**PREVOST**ENREGISTRÉ - REGISTERED  
**ISO 9001 & ISO 14001****SAFETY  
RECALL**

Sr08-22A

| <b>SUBJECT : POWER STEERING HOSE INSPECTION AND REPLACEMENT</b> |                              |

**REVISION : A THIS SAFETY RECALL SUPERSEDES PREVIOUS VERSION.****MODIFICATION TO PROCEDURE TO SEPARATE COACHES AND MTH****APPLICATION**

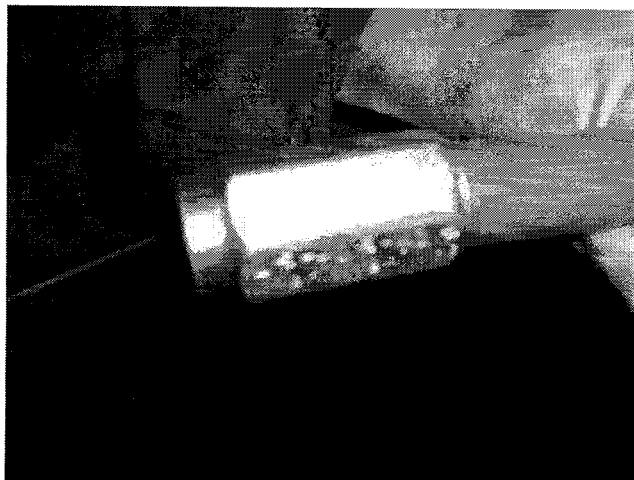
| Position sections of orange protector using worn hose as a reference. |

6. Secure hose to vehicle inside rear wheelhousing.
7. Replace former nylon plastic blocks inside rear baggage compartment with new ones with flared openings (160033).
8. Secure 2 nylon fixing blocks to hoses.
9. Apply some Sika 221 (680532) between the structure (wall) and the fixing blocks for watertightness.
10. Fasten the blocks to the rear baggage compartment wall.
11. Cut worn hose again so as to leave a 1 3/8 inch (35 mm) gap between front hose and the rear hose fitting end.
12. Clean and remove all residues from cut out area.
13. Fasten female part of fitting (501005) onto front hose (left-end thread).

NYLON BLOCK 504727 QTY 1  
FIXING PLATE 504728 QTY 1  
SCREW TC 1/4 X 20 500107 QTY 1

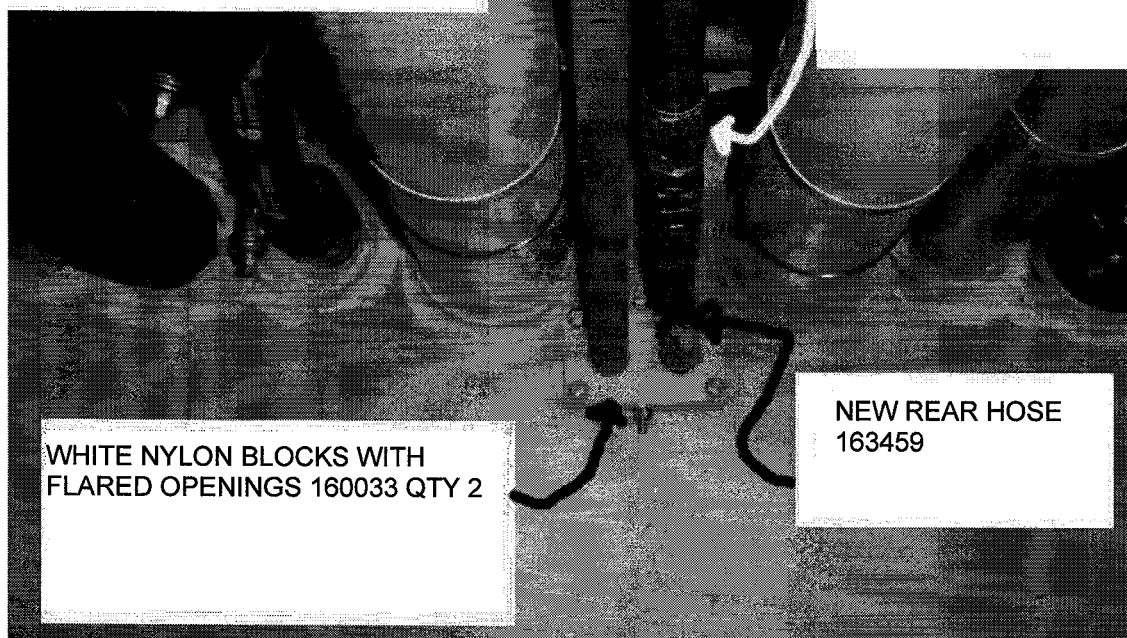
17. Add if necessary, a support inside the rear baggage compartment to prevent any contact between hoses or with surroundings.

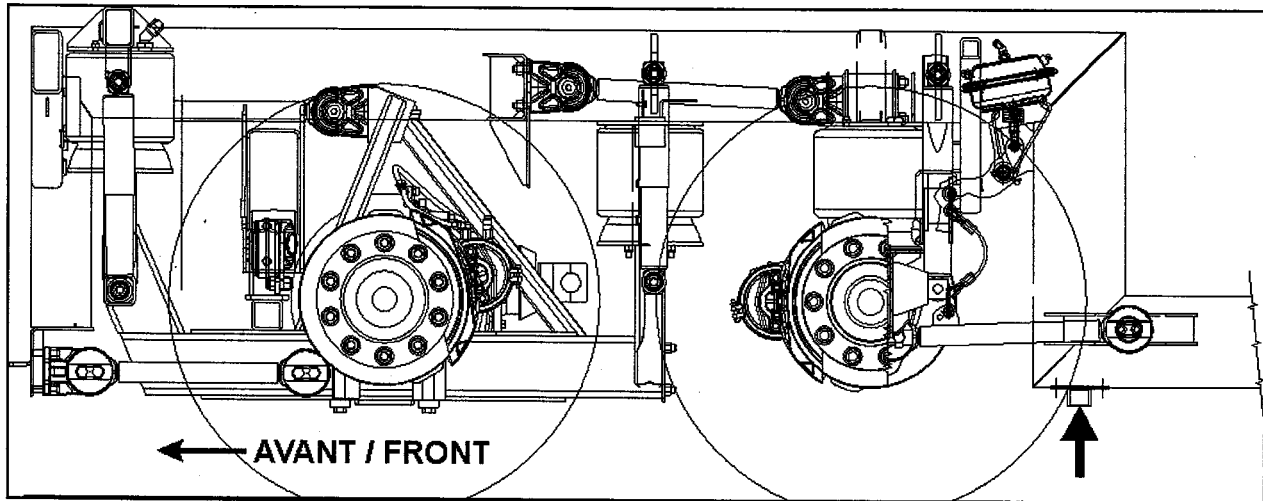
3. From the rear wheelhousing, visually inspect the wall separating the rear baggage compartment from the rear wheelhousing, where the blue power steering pressure hoses go through. Check for signs of oil or rust especially where the hoses come in contact against the nylon blocks. If this is the case, contact your nearest Prevost Service Center or your Regional Service Manager to have the hose replaced. If not, go on with procedure.
4. Clean the wall area near the power steering pressure hoses. Use a cleaner such as "Brake Cleaner" (685248).
5. Amply apply some Sika 221 (680532) onto the cleaned area and the pressure hoses.
6. Split open black protective sheathing (144923) and install (split facing down) over pressure hoses near the wall.
7. Fix protective sheathing using nylon tie wraps (507664).
